**CHANGE ORDER**

No. 1

OWNER St. Charles Parish  
CONTRACTOR Kostmayer Construction LLC  
Contract: Cousins Pump Station Discharge Pipe Replacement  
Project: Cousins Pump Station Discharge Pipe Replacement  
OWNER's Contract No. P130101-1 ENGINEER's Contract No. 20-1270  
ENGINEER Meyer Engineers, Ltd.

**COUSINS PUMP STATION  
 DISCHARGE PIPE REPLACEMENT  
 ST. CHARLES PARISH, OWNER**

exhibit  
**SK-1**  
 of \_\_\_\_ sheets

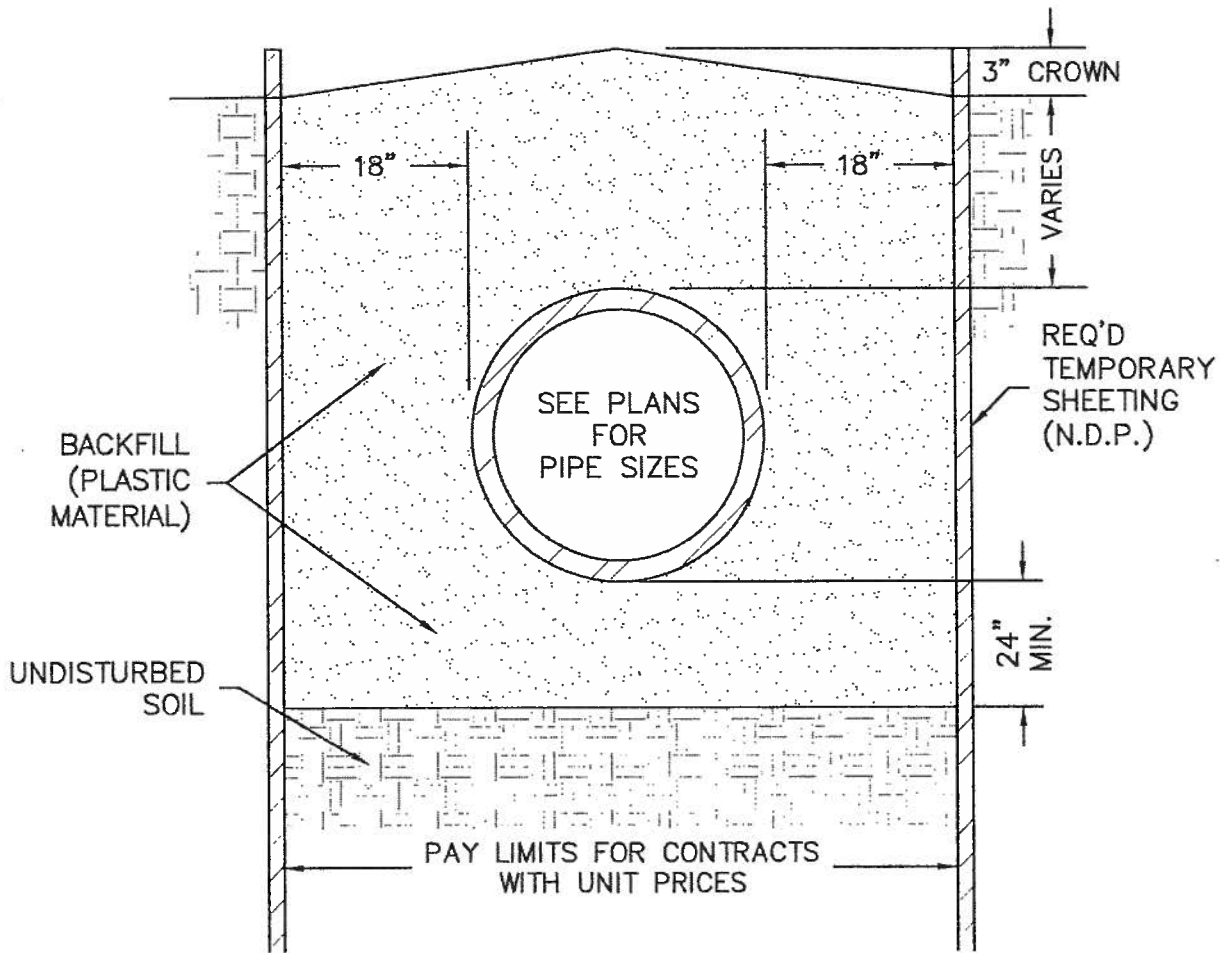
Contractor is directed to proceed promptly with the following change(s):  
**Description:** Replacement of limestone bedding for the discharge pipes to clay as referenced in the attached drawing.

**Attachments:** (List documents supporting change) Revised cross section drawing SK-1 attached to this directive.

**NOTE:**  
 PLASTIC BACKFILL MATERIAL SHALL CONSIST OF EARTH MATERIALS NATURALLY OCCURRING OR CONTRACTOR BLENDED. MATERIALS THAT ARE CLASSIFIED IN ACCORDANCE WITH ASTM D 2487 AS "CL" OR "CH" WITH LESS THAN 35% SAND CONTENT ARE SUITABLE FOR USE AS BACKFILL MATERIAL. MATERIALS CLASSIFIED AS "ML" ARE SUITABLE IF BLENDED TO PRODUCE A MATERIAL THAT CLASSIFIES AS "CH" OR "CL" ACCORDING TO ASTM D 2487. ALL BACKFILL MATERIALS SHALL BE FREE FROM MASSES OF ORGANIC MATTER, STICKS, BRANCHES, ROOTS, AND OTHER DEBRIS INCLUDING HAZARDOUS AND REGULATED SOLID WASTES. MATERIALS PLACED IN THE SECTION MUST BE AT OR ABOVE THE PLASTICITY INDEX OF 10.
